LLNL-AR-454953

Explanation of Significant Difference for Ground Water Nitrate Treatment at the Building 829-Source Treatment Facility Lawrence Livermore National Laboratory Site 300

December 2010

Figure 6. Modified B829-SRC treatment system configuration with nitrate ion-exchange columns.

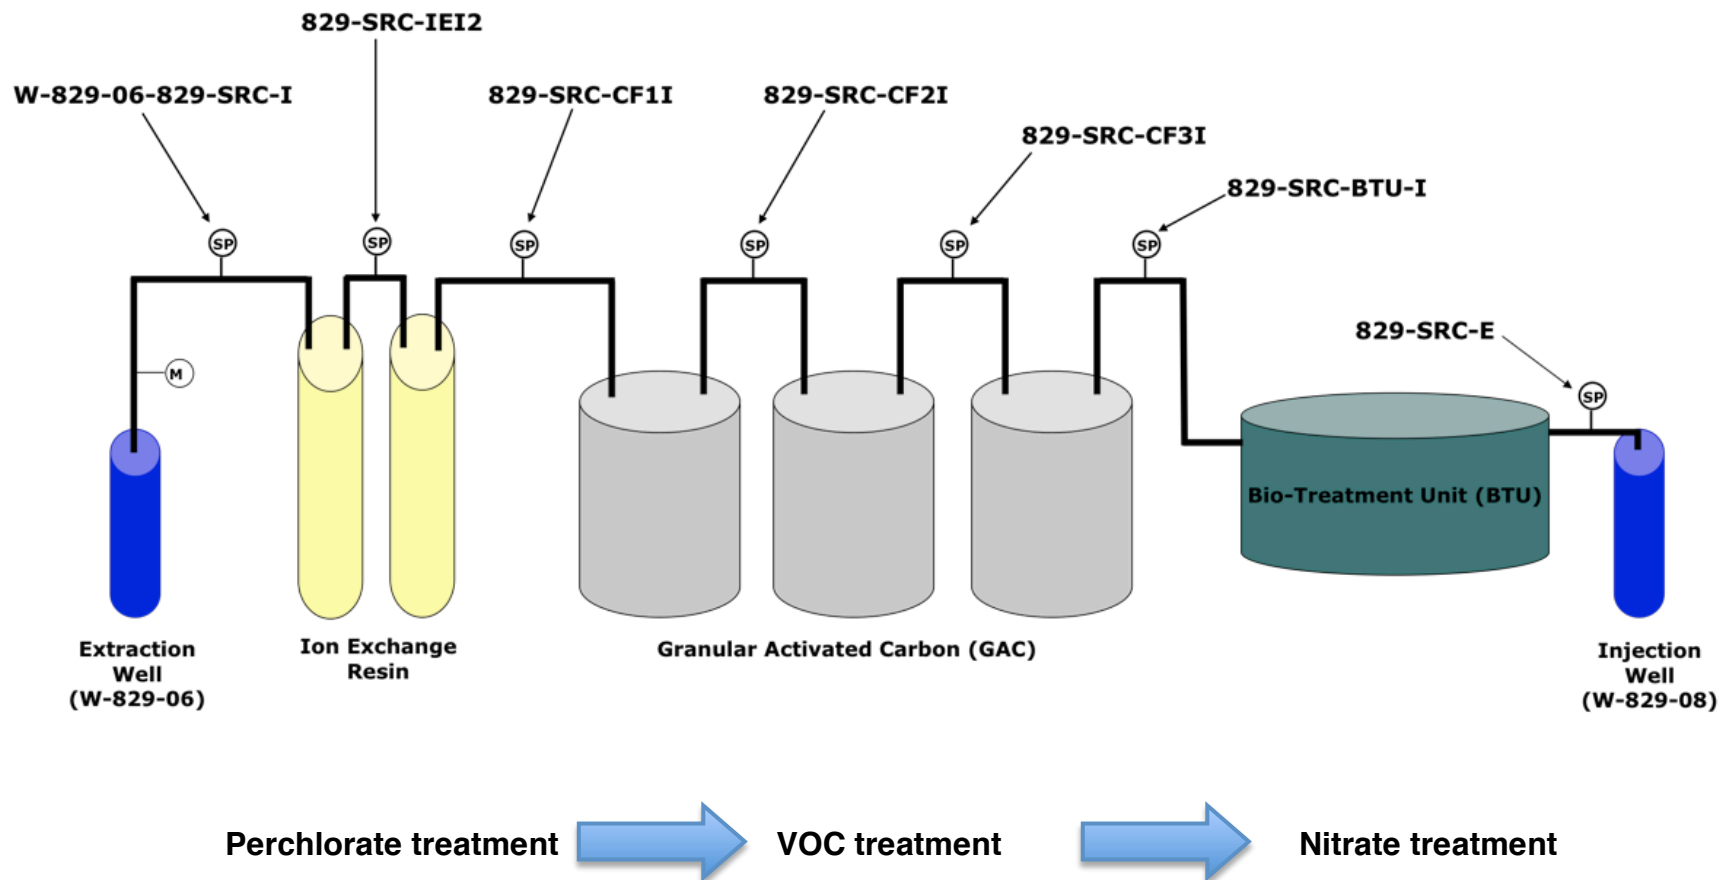
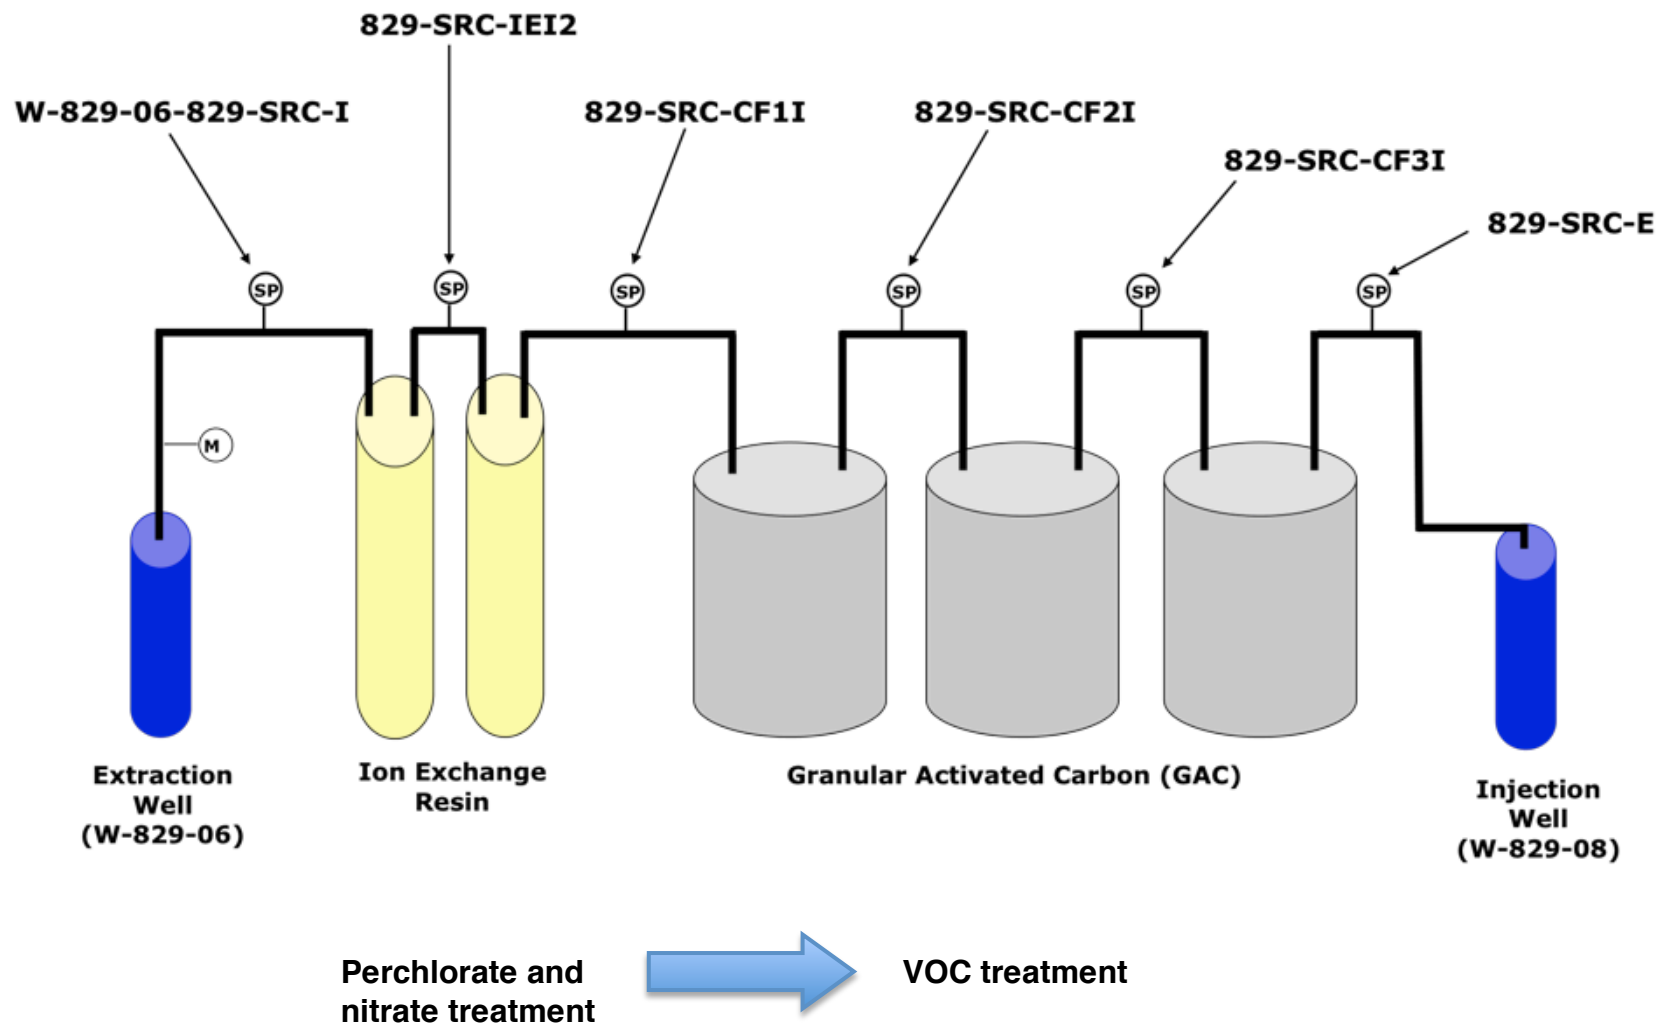
for perchlorate removal, followed by three aqueous-phase granular activated carbon (GAC) canisters connected in-series for VOC removal, and finally, a biotreatment unit (BTU) to remove nitrate (Figure 4). The treated effluent is monitored to ensure ground water COC concentrations have been reduced to meet the VOC, perchlorate, and nitrate effluent limitations of $0.5 \mu\text{g/L}$, $4 \mu\text{g/L}$, and 45 mg/L , respectively. The treated effluent is then reinjected into upgradient well W-829-08.

This ESD describes a change in treatment technology for nitrate in ground water at the B829-SRC facility, where ground water extracted from well W-829-06 will be treated using ion-exchange treatment technology to remove nitrate. This is a change from current nitrate biotreatment technology at the B829-SRC facility as described in the ROD.

This ESD documents the removal of the BTU and the use of the existing ion-exchange technology already in place at the B829-SRC treatment facility to continue to remove nitrate from extracted ground water because:

1. The ion-exchange columns are effectively removing the nitrate to meet effluent discharge limits, rendering the BTU unnecessary,
2. The BTU is impractical under the operational conditions at B829-SRC.
3. Elimination of the BTU is expected to increase the overall operational efficiency of the B829-SRC treatment facility, and decrease operation and long-term maintenance (O&M) efforts.

The proposed B829-SRC treatment facility configuration is shown in Figure 6. The ion-exchange resin used for perchlorate removal is an anion-exchange resin that also effectively removes nitrate. The resin has a higher affinity for binding perchlorate, so nitrate will be released as the perchlorate is loaded. There are two ion-exchange columns in series, and routine monitoring for both nitrate and perchlorate will be performed between columns to ensure change-out of columns is performed to meet effluent limitations for perchlorate and nitrate. When breakthrough of nitrate or perchlorate occurs after the first ion-exchange column, the first column will be removed, the second column will be moved to the first position, and a new column would be placed in the second position. The ion-exchange technology has been demonstrated to be effective, and requires relatively little maintenance. No changes to the size or number of ion-exchange columns are needed to remove nitrate and perchlorate to meet effluent limits.

Figure 5. Nitrate (as NO₃) concentrations in the influent and effluent to the B829-SRC Ground Water Treatment System (GWTS) ion-exchange (IX) columns.

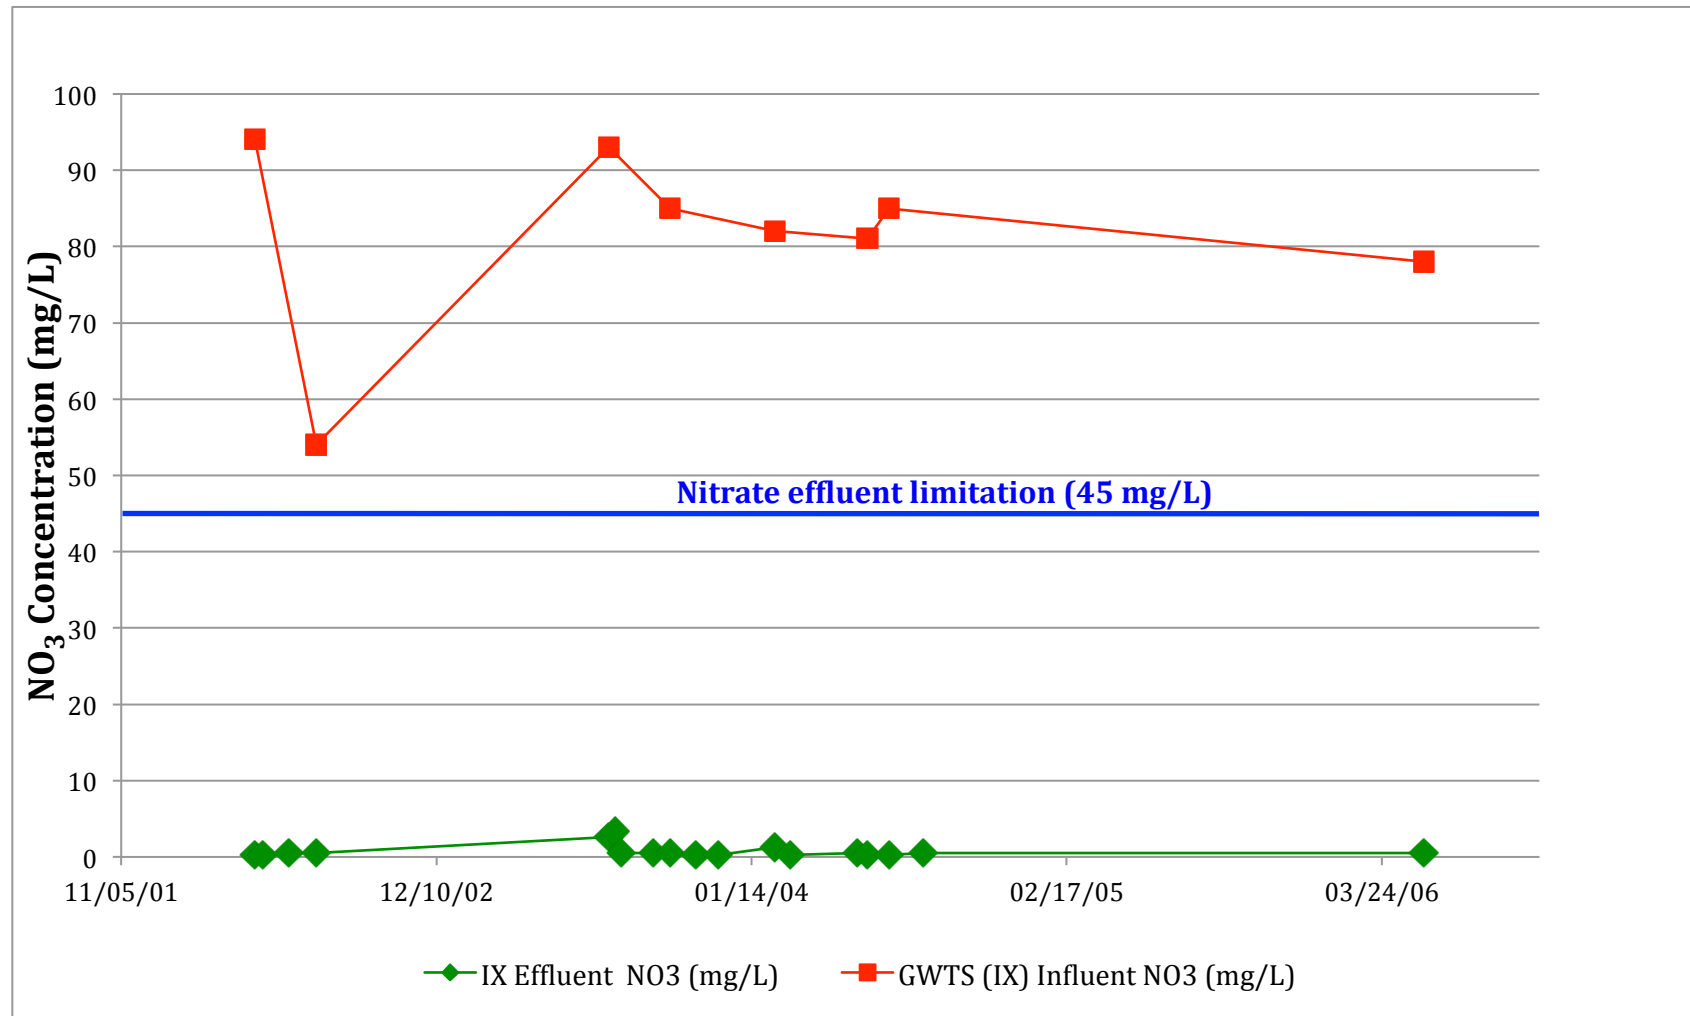
Table 1 and Figure 5 present nitrate analytical data for water samples collected at sample ports at the influent to and effluent from the ion-exchange resin columns at the B829-SRC treatment facility. These data demonstrate that the ion-exchange resin effectively reduces nitrate concentrations to significantly below the 45 mg/L nitrate effluent limitation. Because the BTU is located after the ion-exchange resin columns, the decrease in nitrate concentration to near or below the 0.5 to 1 mg/L practical quantitation limit is solely the result of nitrate treatment by the ion-exchange resin. Therefore, the BTU is not necessary to meet discharge limits for nitrate.
